METROPOLITAN GOVERNMENT OF NASHVILLE AND DAVIDSON COUNTY

Metropolitan Historic Zoning Commission
Sunnyside in Sevier Park
3000 Granny White Pike
Nashville, Tennessee 37204
Telephone: (615) 862-7970
Fax: (615) 862-7974

STAFF RECOMMENDATION
603 Rudolph Avenue
August 20, 2014

Application: New construction—infill duplex
District: Lockeland Springs-East End Neighborhood Conservation Zoning Overlay
Council District: 06
Map and Parcel Number: 08306034600
Applicant: Cathedral Homes
Project Lead: Melissa Baldock, melissa.baldock@nashville.gov

Figure 1. 603 Rudolph Avenue

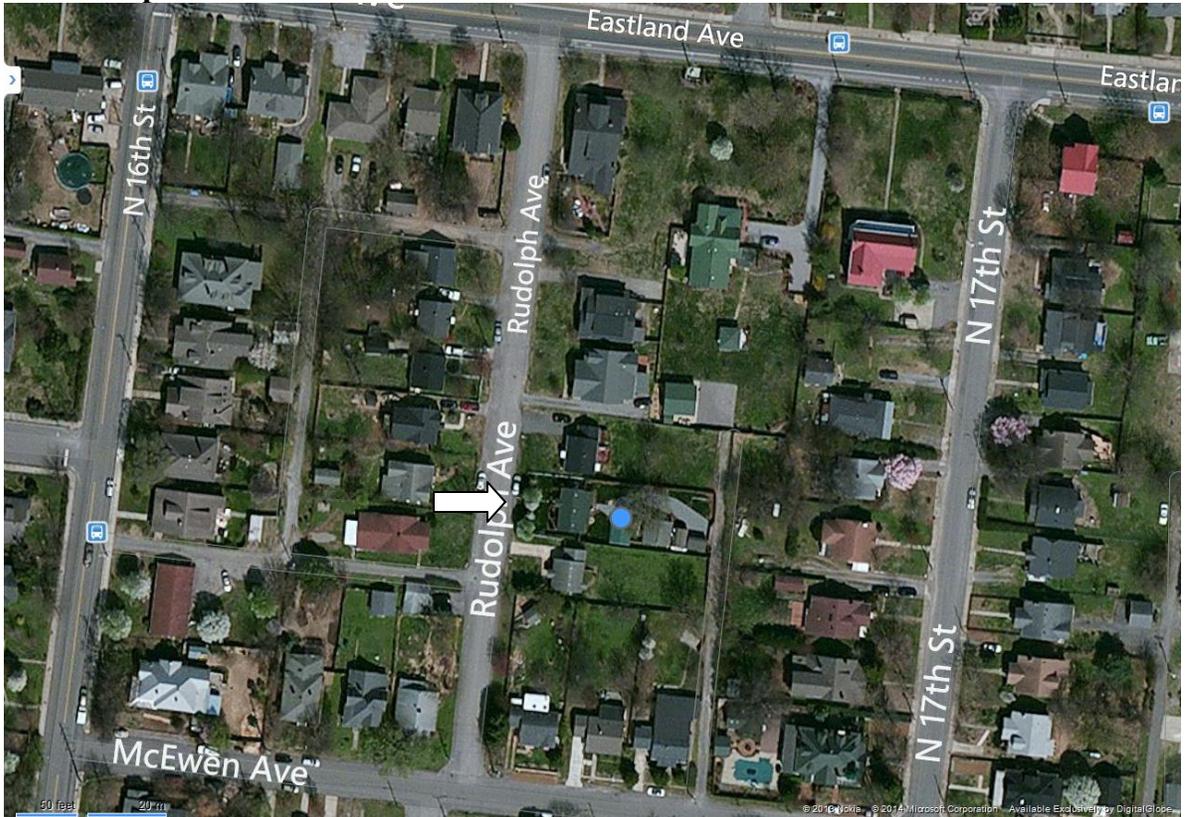
Background: 603 Rudolph Avenue is a non-contributing structure constructed c.1950 (Figure 1). MHZC staff issued an administrative permit to demolish the primary structure and the outbuildings on the lot in June 2014.

Front & Rear Elevations
Scale 1/8" = 1'

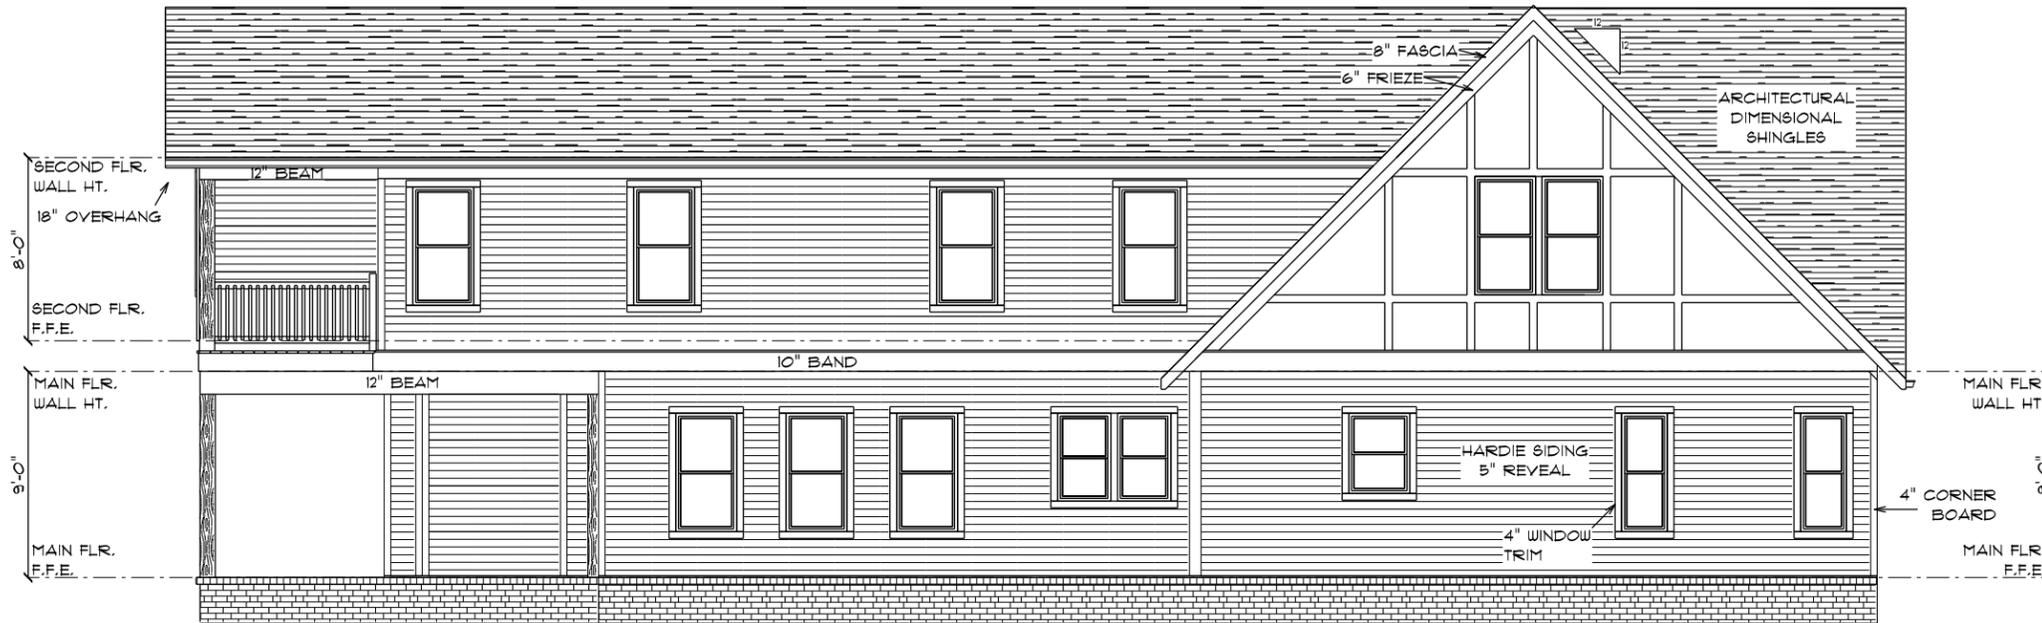
Roof form: The infill's primary roof form is a cross gable. The front gable will have a 16/12 slope, and the side gable will have a 12/12 slope. At the rear will be a lower sloped gable form, with a pitch of 3/12. There is a shed dormer on the front façade with a slope of 5/12. The dormer is appropriately set off of the ridge of the house, and is inset two feet (2') from the wall below. Staff finds that the infill's roof forms are compatible with the historic character of Lockeland Springs and meet Section II.B.5. of the *Lockeland*

Orientation: The duplex infill will be oriented so that both units have front entries facing Rudolph Avenue, which is appropriate. The left unit will be situated behind an enclosed stoop, which is four feet (4') deep. While the design guidelines state that porches should be at least six feet (6') deep, it is appropriate for entries behind a stoop to be shallower. The right entry is located behind a partial-width front porch that is eight feet (8') deep. Although the entries to the two units have different configurations, staff finds that they are compatible with each other and they are of equal importance. Staff asks that a condition of approval be that the applicant add walkways leading from the street to each of the entries. In addition, staff asks that the front porch and stoop stairs be added to the drawings. With these conditions, staff finds that the duplex's orientation meets Section II.B.6. of the *Lockeland Springs-East End Neighborhood Conservation Zoning Overlay: Handbook and Design Guidelines.*

Proportion and Rhythm of Openings: The window openings are generally twice as tall as they are wide, and the windows on the second level are generally not taller than those on the first level, thereby meeting the historic proportion of window openings. There are no large expanses of wall space without a window or door opening. Staff therefore finds that the project's proportion and rhythm of openings meet Section II.B.7. of the *Lockeland Springs-East End Neighborhood Conservation Zoning Overlay: Handbook and Design Guidelines.*

1. The finished floor height be consistent with the finished floor heights of the adjacent historic houses, to be verified by MHZC staff in the field;
2. Staff approve a brick sample, the roof shingle color, the design and material of the front steps and porch floor, the design and material of any front stair or porch railing, and the final details, dimensions and materials of windows and doors prior to purchase and installation;
3. Walkways be added from the street to each of the front entries of the duplex units; and
4. The HVAC units be located behind the house or on either side, beyond the midpoint of the house.

Left & Right Elevations
 Scale 1/8" = 1'

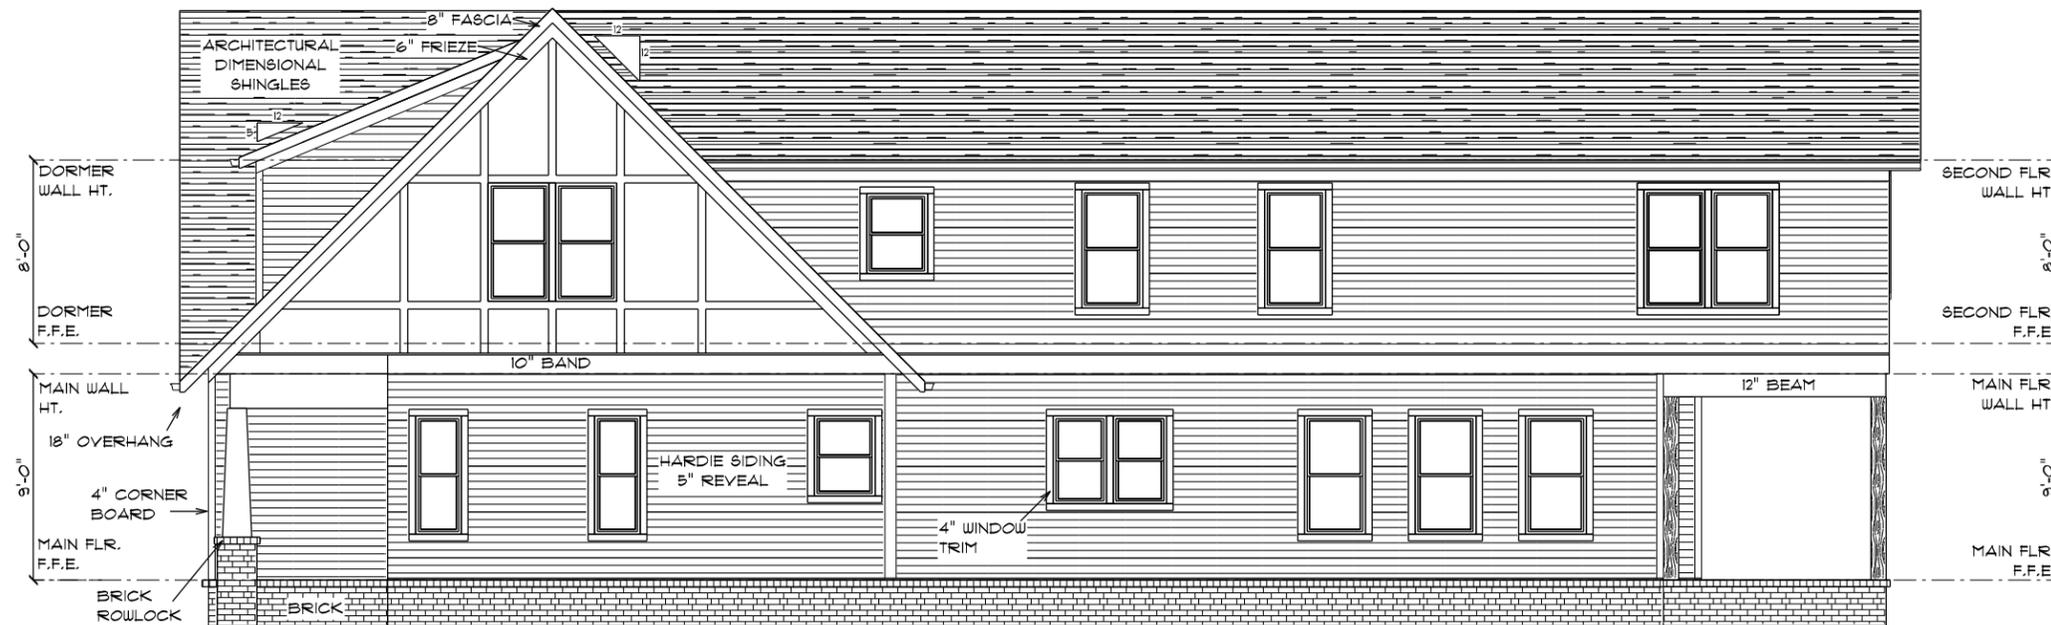
Appurtenances & Utilities: No changes to the site's appurtenances were indicated on the drawings. The location of the HVAC and other utilities was also not noted. Staff asks that the HVAC units be located on the rear façade, or on a side façade beyond the midpoint of the house.
